Access Compliance Report

Public Rights-of-Way

(Curb Ramps)

Intersection ID: 11956	Main Street: E_9TH_ST	Cross Street: N_COLLEGE_ST	Location: W
ADA ID: 06C1D18CEE32	Ramp Type: PerpDiag	Initial Pass/Fail: Fail	Overall Compliance: No
Severity Score: 10			
Codes/Mitigation Info/Possible Solution		Field Measurements/Component Compliance

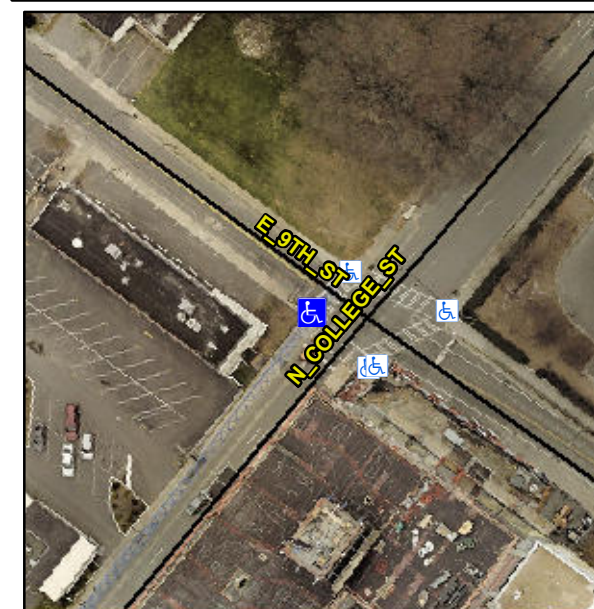
R304.5.1, R304.5.3

Compliance	Description	Data	Compliance	Description	Data
N/A	Ramp Length (in)	95.5	Yes	Ramp Slope (%)	5.9
No	Ramp Width (in)	47.5	No	Ramp XSlope (%)	3.0
N/A	Flare Type LT	N/A	N/A	Flare Type RT	N/A
N/A	Flare Slope LT (%)	N/A	N/A	Flare Slope RT (%)	N/A
N/A	Flare Traversable LT?	N/A	N/A	Flare Traversable RT?	N/A
N/A	Landing Length (in)	N/A	N/A	DWS Provided?	N/A
N/A	Landing Width (in)	N/A	N/A	DWS Contrast?	N/A
N/A	Landing Slope (%)	N/A	N/A	DWS Length (in)	N/A
N/A	Landing X Slope (%)	N/A	N/A	DWS Full Width?	N/A
N/A	Landing Curb? (Y/N)	N/A	N/A	DWS Offset (in)	N/A
N/A	Shared Landing?	N/A			
N/A	Gutter Ponding?	N/A	N/A	Gutter Slope (%)	N/A
N/A	Gutter Lip Ht (in)	N/A	N/A	Gutter X Slope (%)	N/A
N/A	Painted X Walk1?	Yes	N/A	Painted X Walk2?	Yes
	X Walk 1 Direction	To SE		X Walk 2 Direction	To NE
N/A	X Walk 1 Width (in)	95.0	N/A	X Walk 2 Width (in)	95.0
	X Walk 1 Slope (%)	2.6		X Walk 2 Slope (%)	1.9
	X Walk 1 X Slope (%)	1.2		X Walk 2 X Slope (%)	2.5

Remove & Replace Curb Ramp With Two New Directional Ramps or Equivalent.
